## PRELIMINARY STRUCTURAL ASSESSMENT REPORT

**PROJECT:** Ronald Reagan Building – 14<sup>th</sup> Street ramps  
Investigation of Ceiling Failure at the 14<sup>th</sup> Street North Vehicle Ramp

Figure 3: Section showing wire hangers

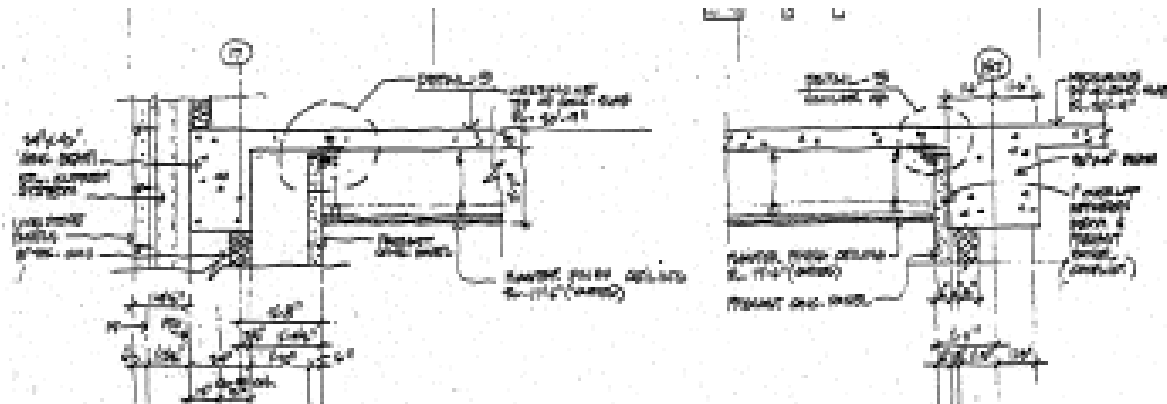
Existing building drawings do not provide ceiling support details even though wire hangers seem to have been drawn in. Specifications for the plaster ceilings were not available at this time. Shop drawings for the plaster ceilings, hangers and framing were not available at this time.
